PLAN AND PROFILE OF PROPOSED STATE HIGHWAY

PRINCE WILLIAM PARKWAY INTERCHANGE AT REALIGNED BALLS FORD ROAD

VDOT Proj.No.6234-076-266

Notice of Design Change (NDC) #02
JUNE 2021

25 Scale Base Layout Plan

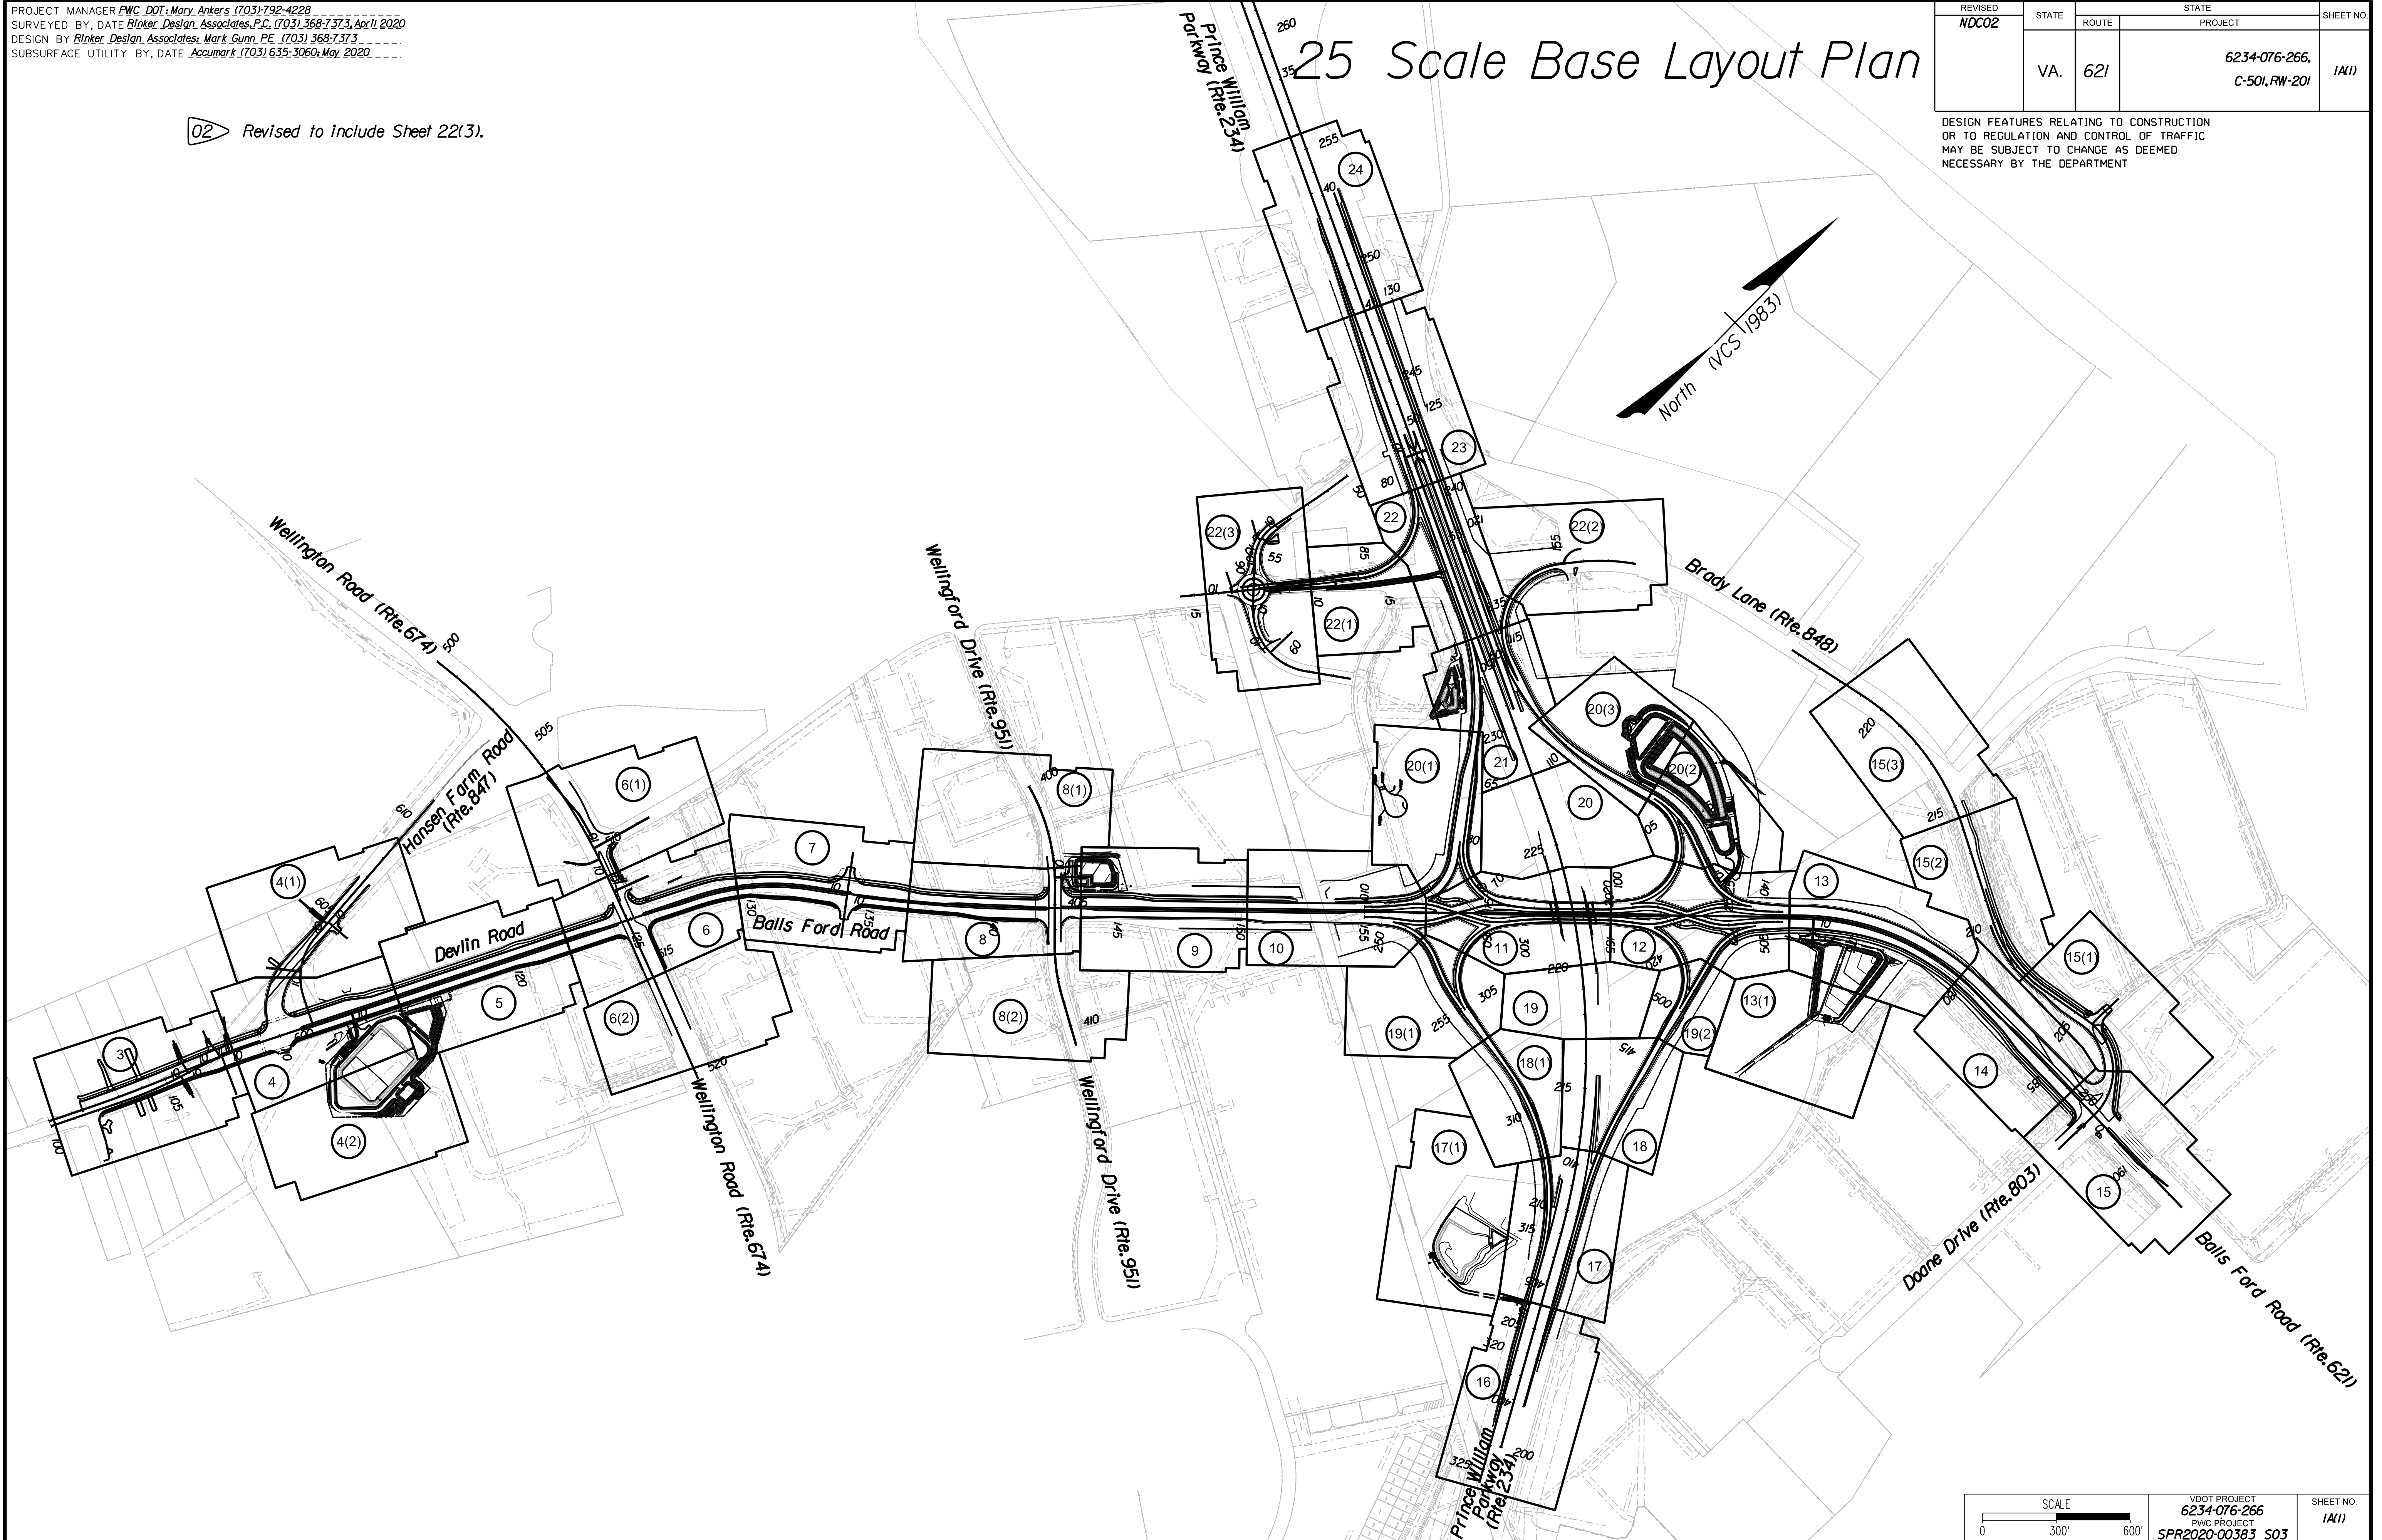
02 Revised to include Sheet 22(3).

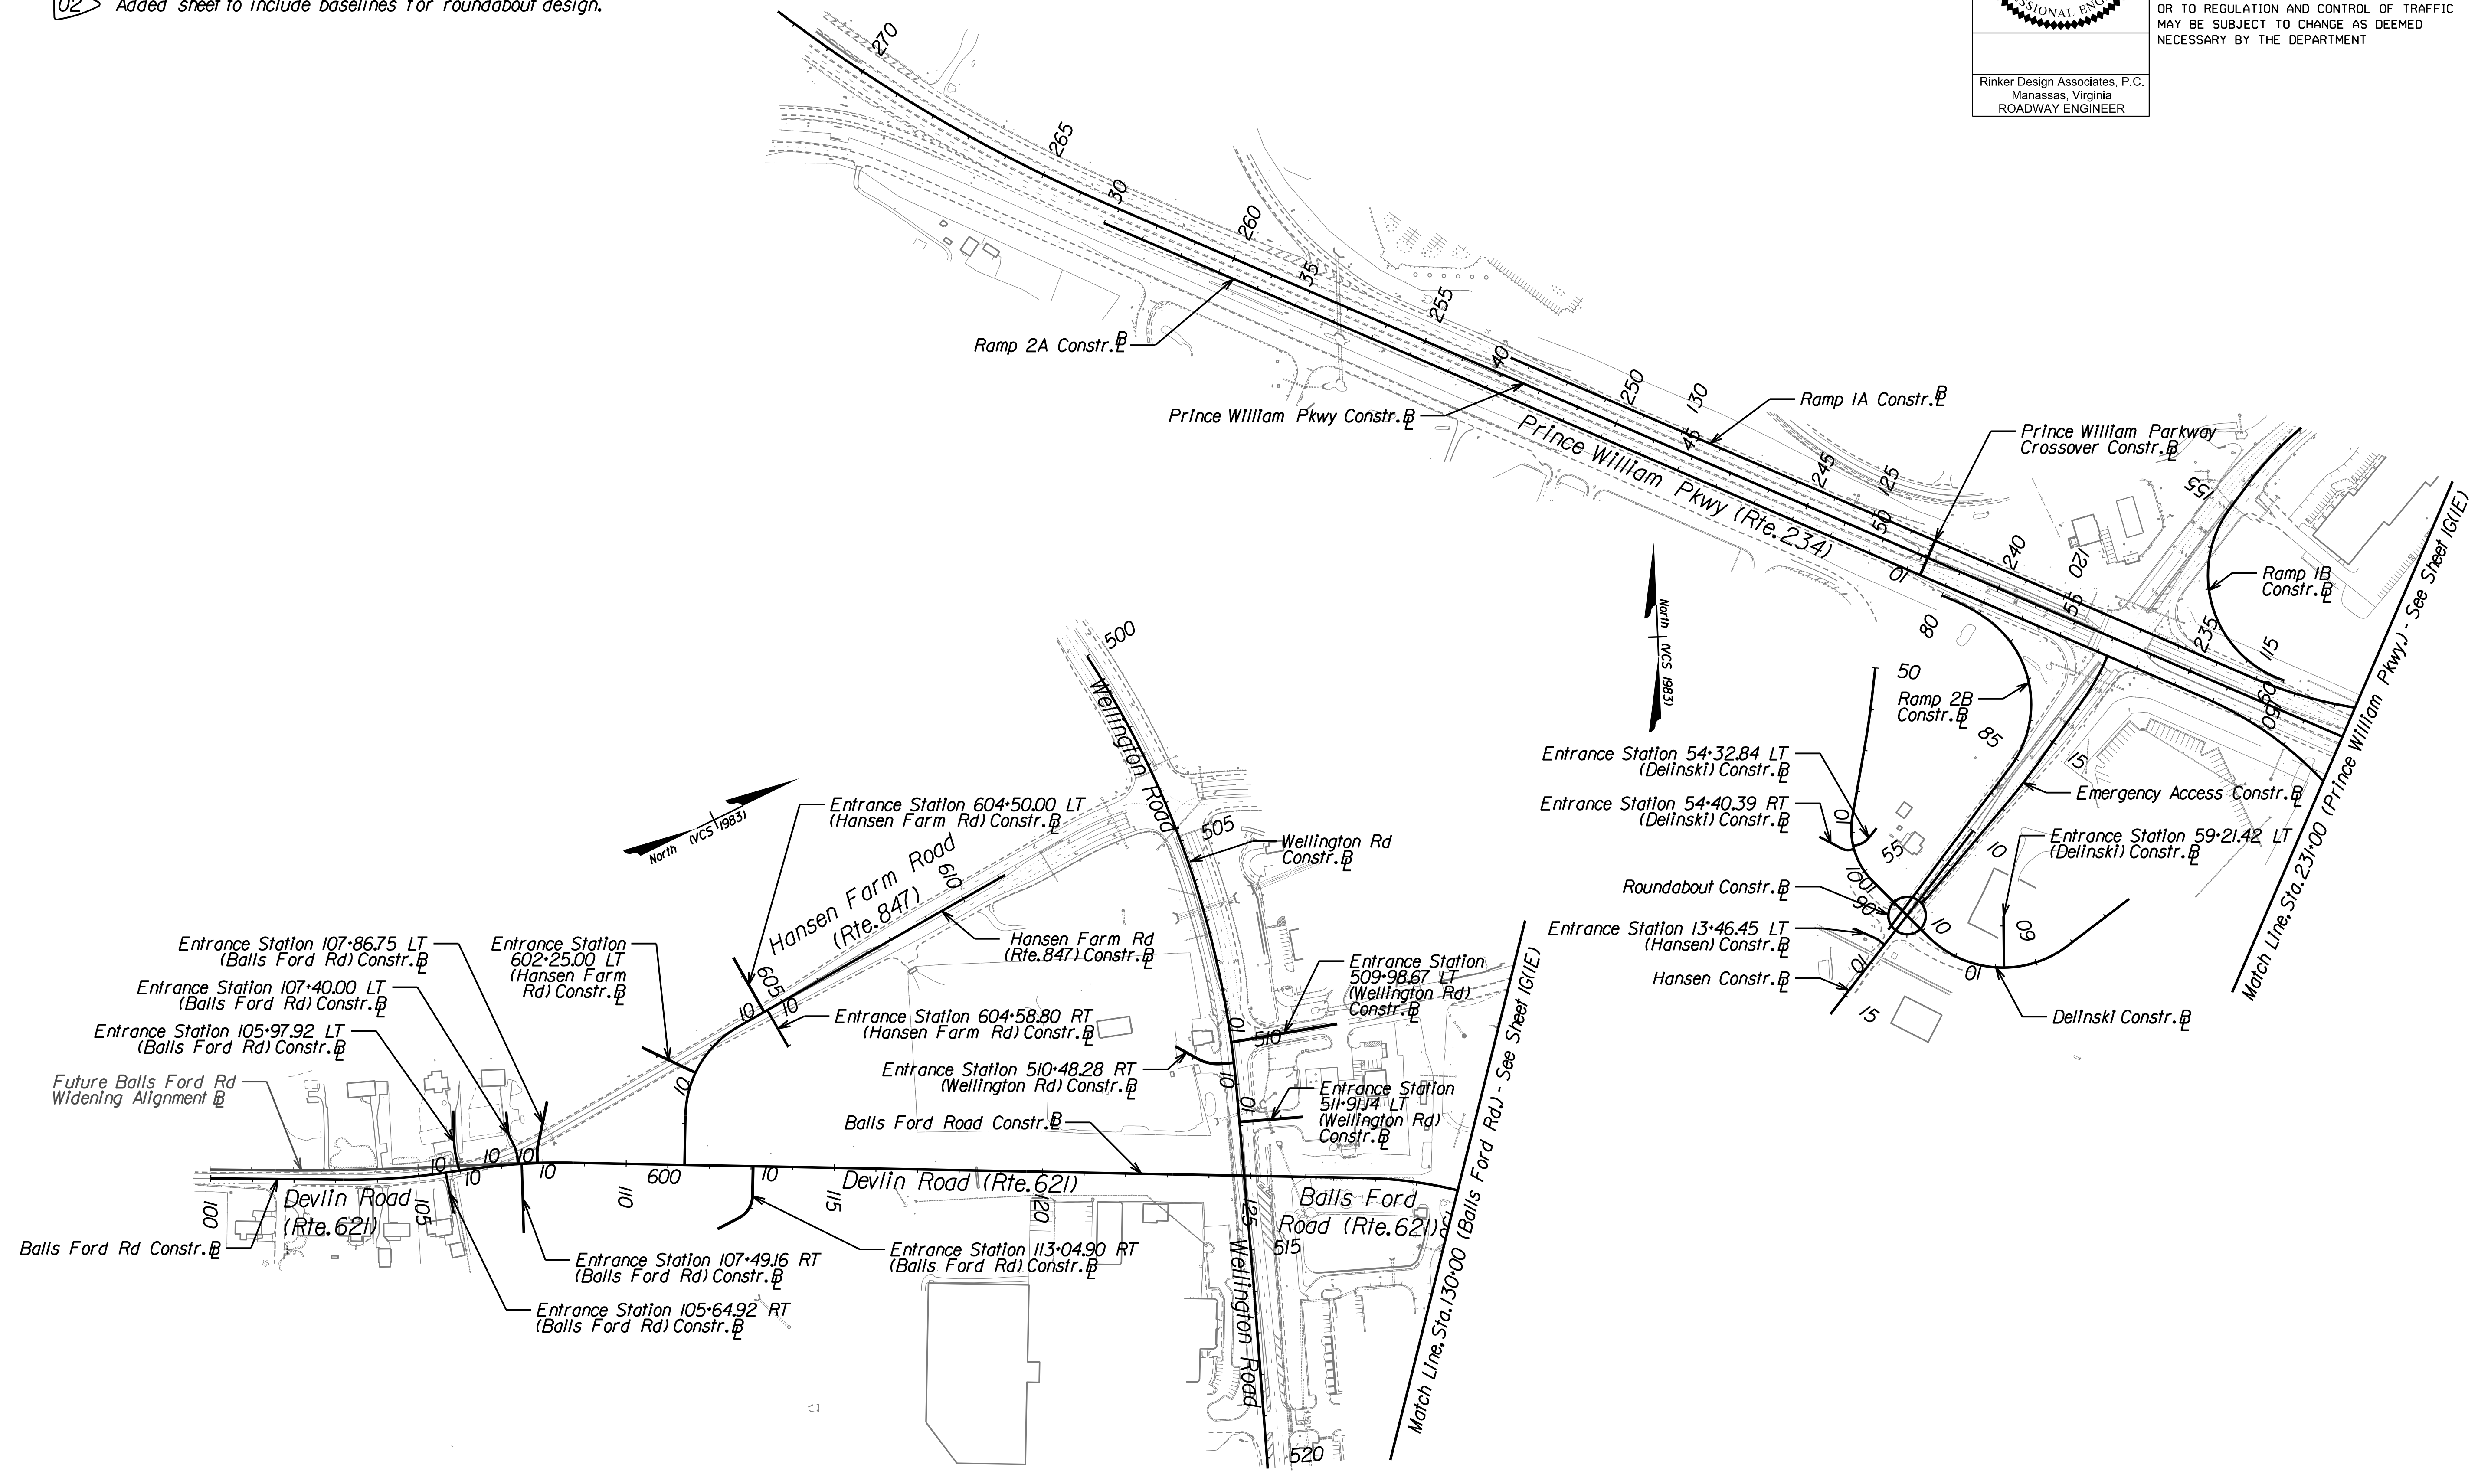
02 Added sheet to include baselines for roundabout design.

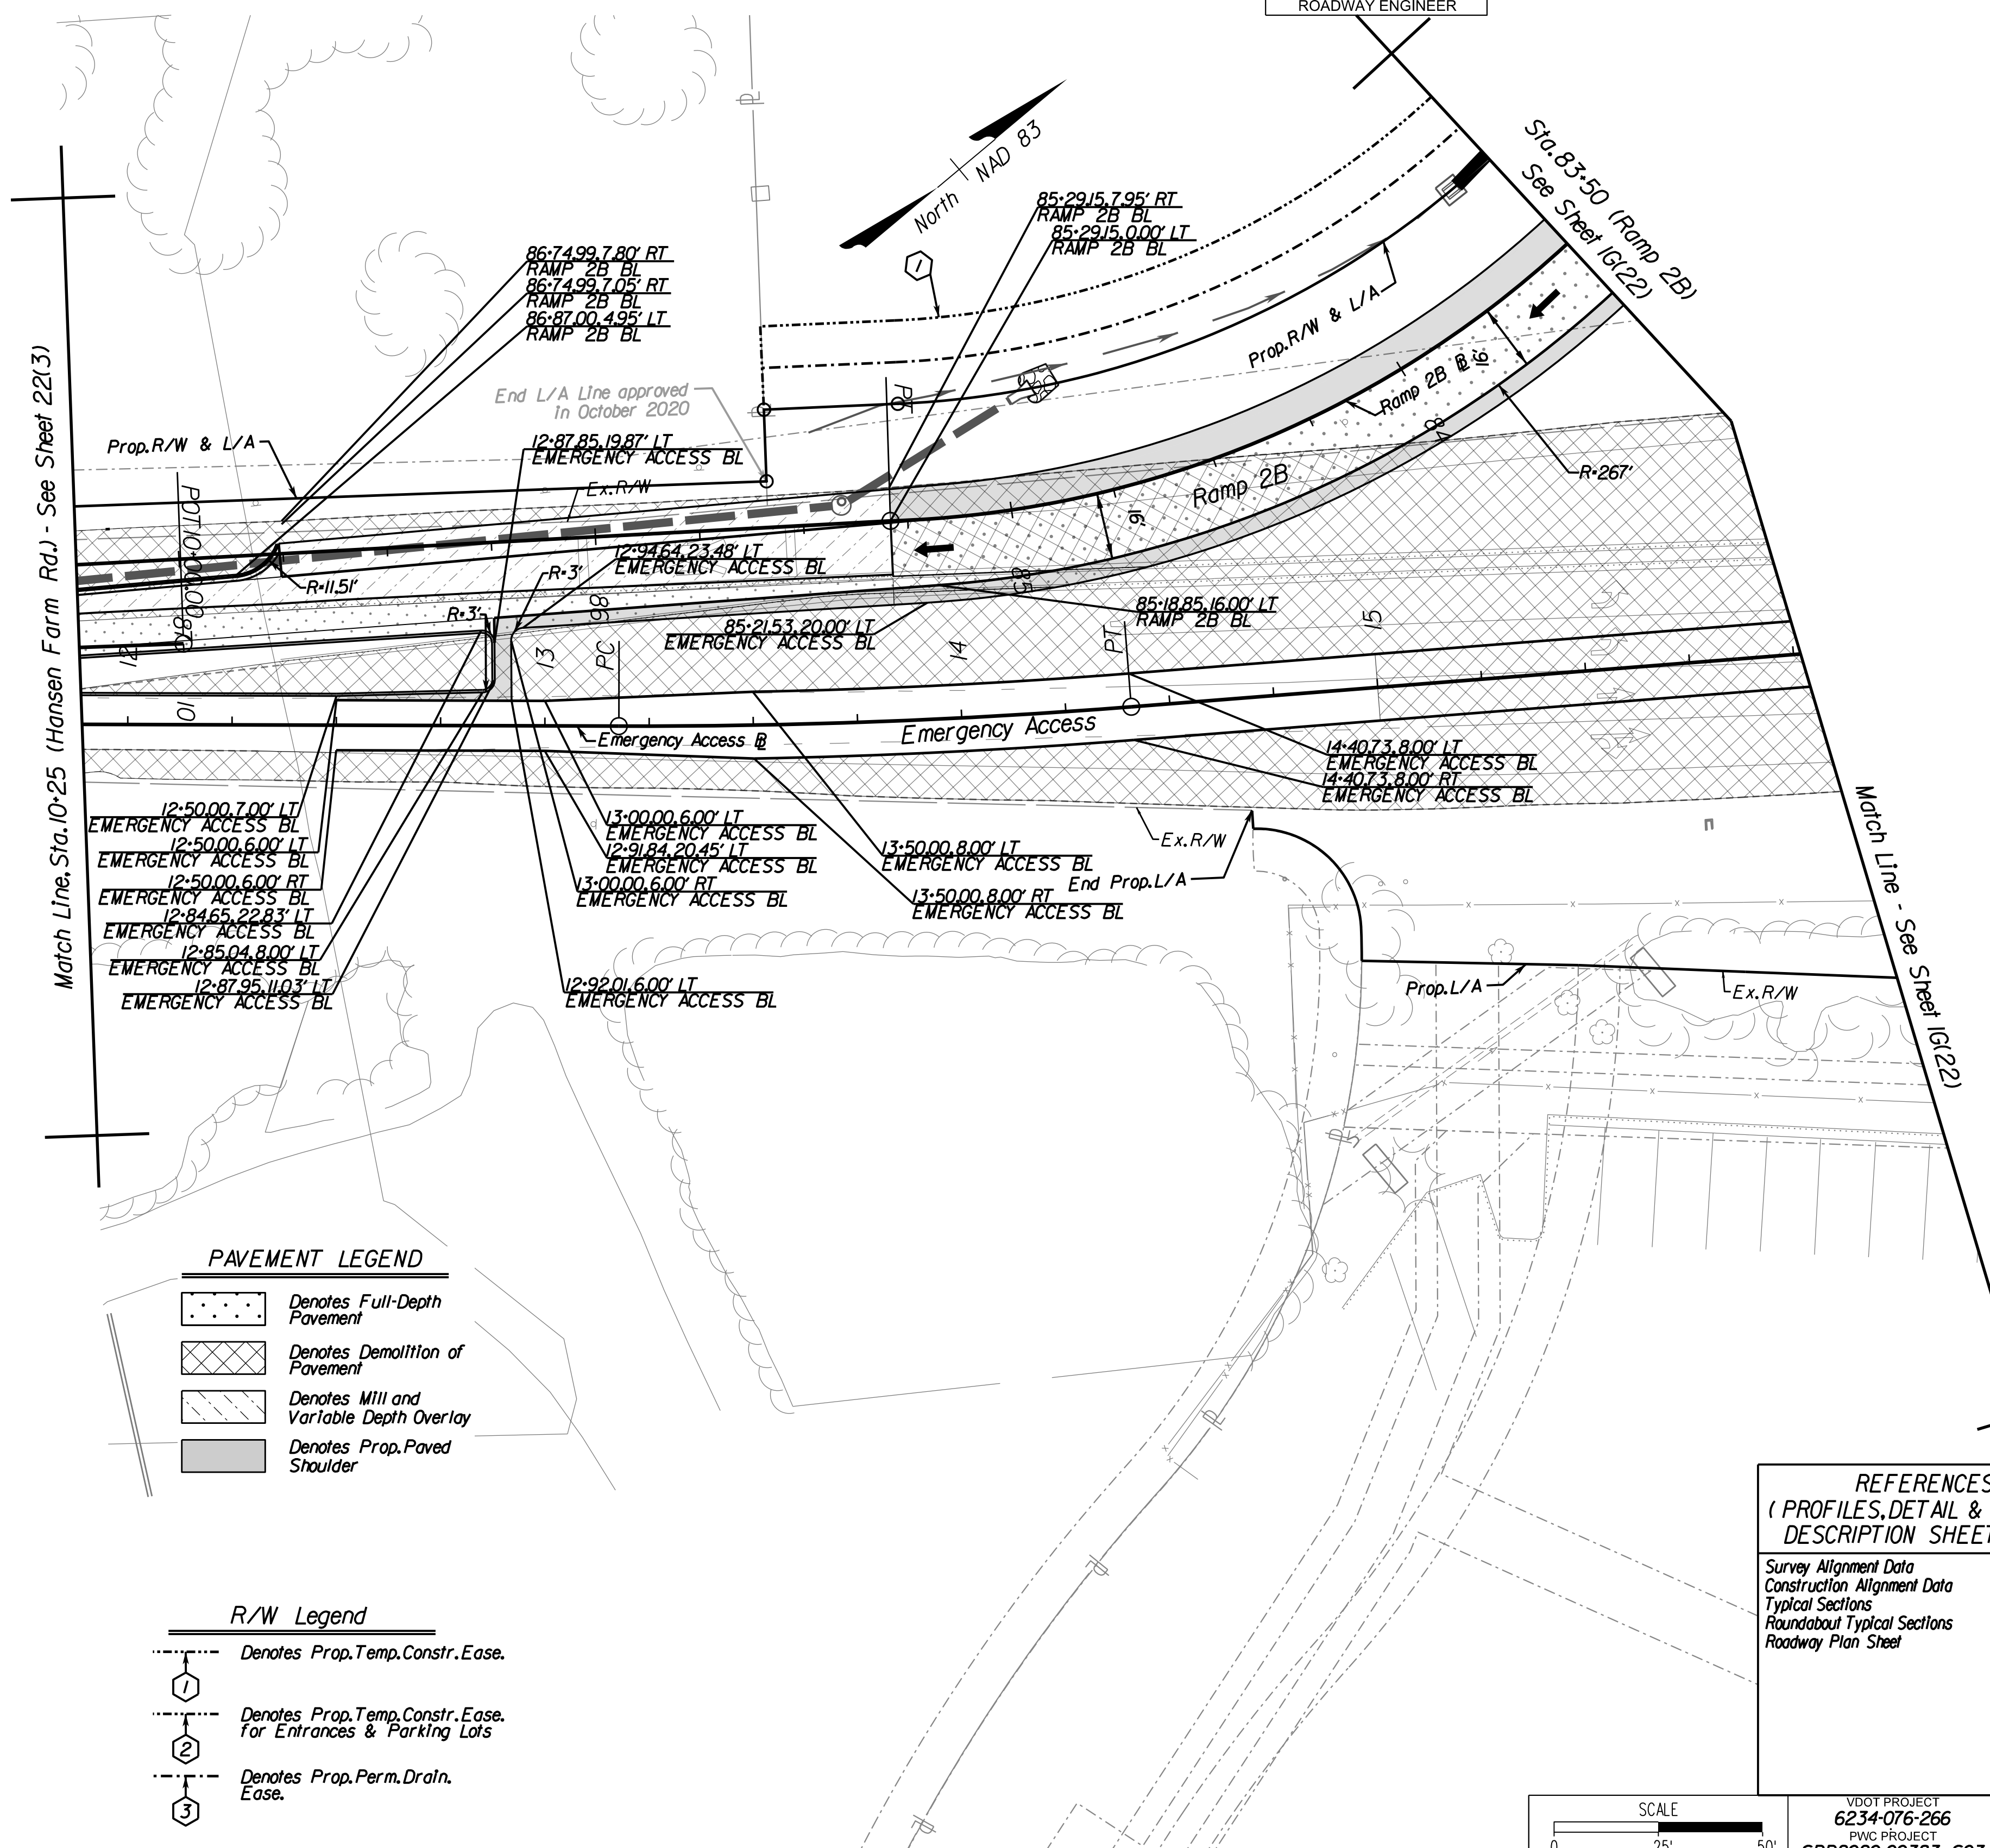
02 Revised sheet to include roundabout changes.
